## Minnehaha Creek Watershed District

## REQUEST FOR BOARD ACTION

**TITLE:** Authorization of Comment Responses for the Watershed Management Plan

Authorization to distribute responses to comments received during the 60-day review period for the draft Watershed Management Plan

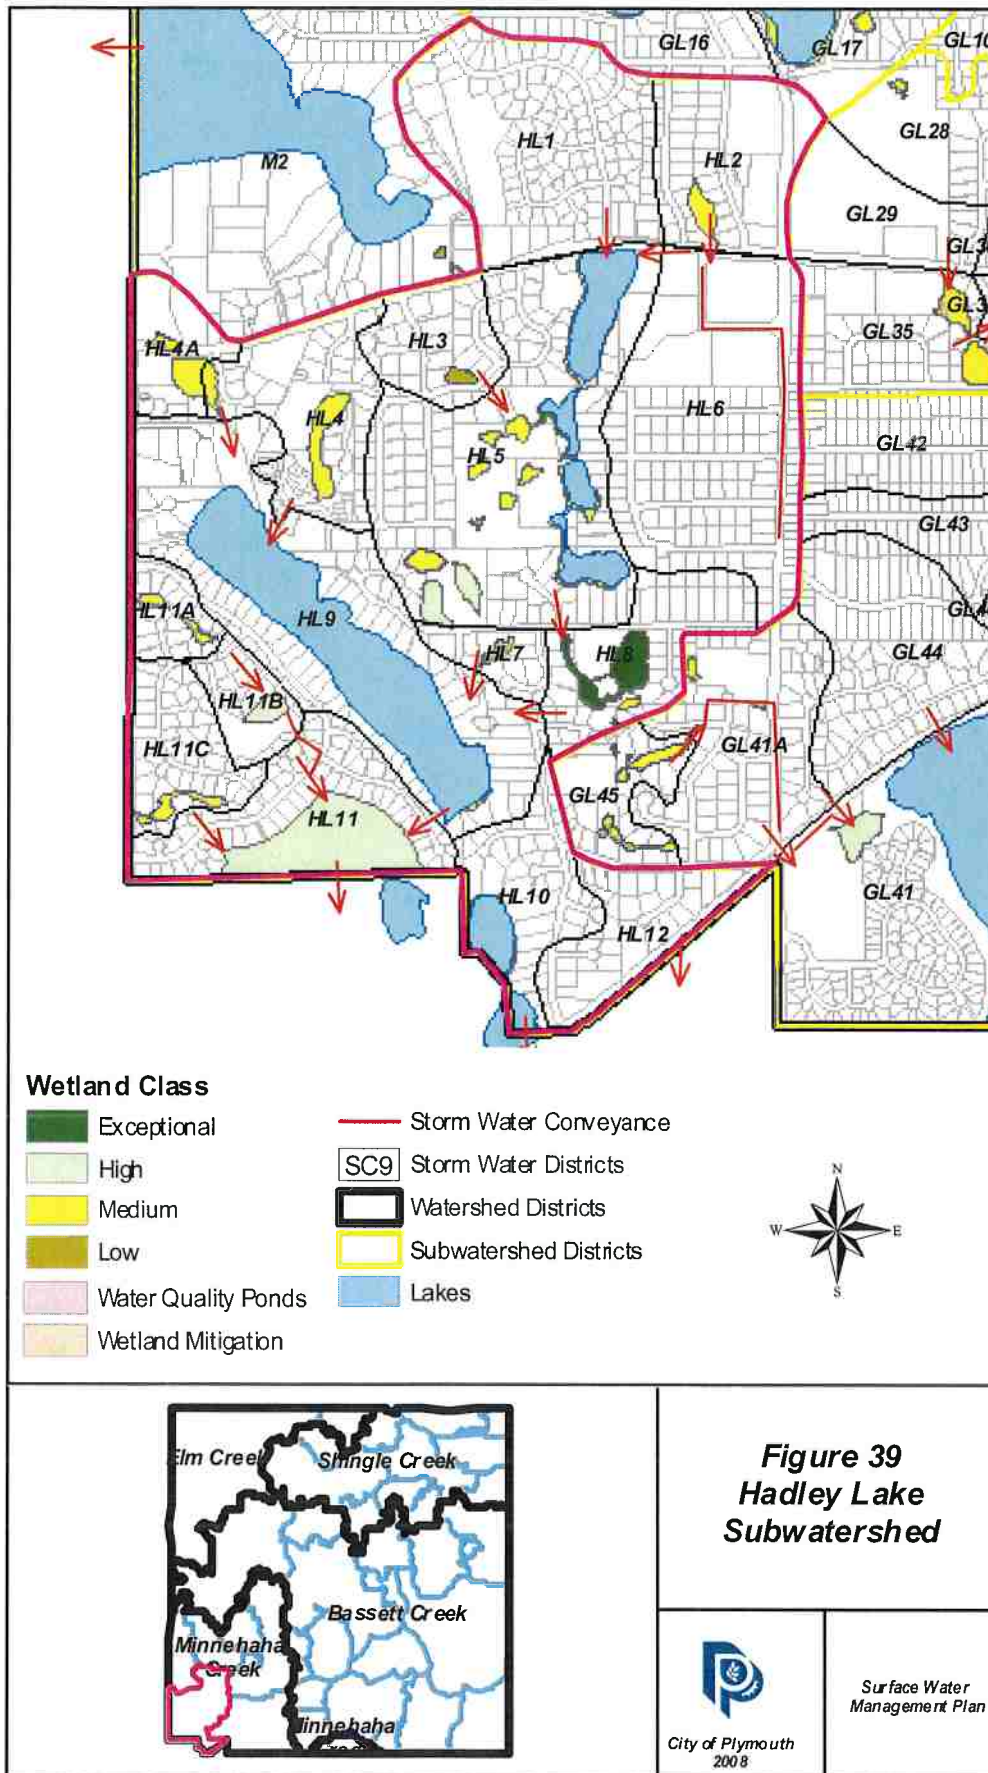
- Page 103: paragraphs 2 and 5 are almost the exact same text.
- Page 103: last paragraph "not" should be changed to "no."
- Page 113: the City has a fish survey posted on the City website dated October 2011 for Gleason Lake if interested.
- Page 377: Figure 3.11. City records indicate Hadley Lake drains to the south-southwest and drainage on the southwest corner of County Road 101 and County Road 6 flows west and eventually reaches Hadley (see attachment).

172	3.9.3	Page 337: Figure 3.11. City records indicate Hadley Lake drains to the south-southwest and drainage on the southwest corner of County Road 101 and County Road 6 flows west and eventually reaches Hadley.	Plymouth	Thank you for noting this. There is an error with the drainage areas on this map that will be corrected.
173	3.9.3	Section 3.9.3 Gleason Lake Subwatershed Plan – Stormwater runoff – page 395 – The comment “impervious cover, altered drainage, and stormwater runoff within a watershed increases, the quality of lakes, streams, and wetlands decreases” is not necessarily a correct statement. Land use change from agricultural to urban provides an opportunity to implement BMP that can potentially improve water quality. This emphasizes the importance of the MCWD's rules and regulations.	TRPD	The sentence begins with the word "generally" in acknowledgement that there are exceptions. The District's Stormwater Management rule accounts for these cases of conversion of agricultural to urban land use by requiring no net increase in phosphorus loading from the site as modeled in a meadow condition.
